Access Compliance Report

Public Rights-of-Way

(Pedestrian Signals)

Intersection ID: N/A	Main Street:	Cross Street: N/A	Location: N/A
ADA ID: 0B53A77C9E7F	Signal Type: Two Push Buttons-APS	Overall Compliance: No	Severity Score: BTN 1:N/A BTN 2: N/A No BTN: N/A
Codes/Mitigation Info/Possible Solution		Field Measurements/Component Compliance

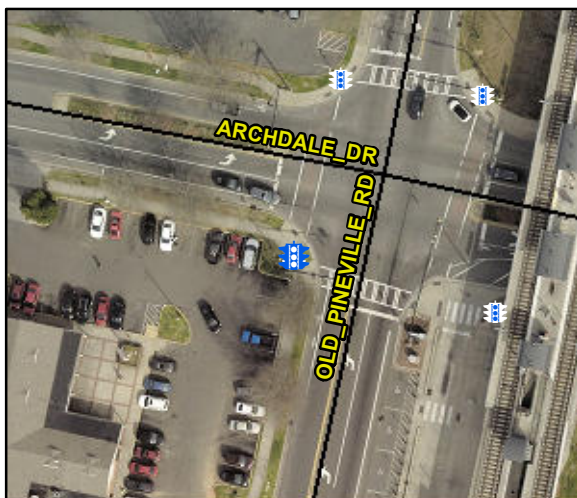
PROW/ADA: TMUTCD 4e.08, R404.3, R406.2

Yes	B 1 Clear Xing Direction?	ClearlyMarked	Yes	B 2 Clear Xing Direction?	ClearlyMarked
	B 1 Crossing Direction	To E		B 2 Crossing Direction	To N
Yes	B 1 DistanceTo XWalk (in)	0.0	Yes	B 2 DistanceTo XWalk (in)	0.0
No	B 1 DistanceTo Curb (in)	173.0	No	B 2 DistanceTo Curb (in)	192.0
Yes	B 1 Diameter (in)	2.0	Yes	B 2 Diameter (in)	2.0

Possible Solutions: Replace Signal Push Button With APS Button on New Post. Remove & Relocate Sign.
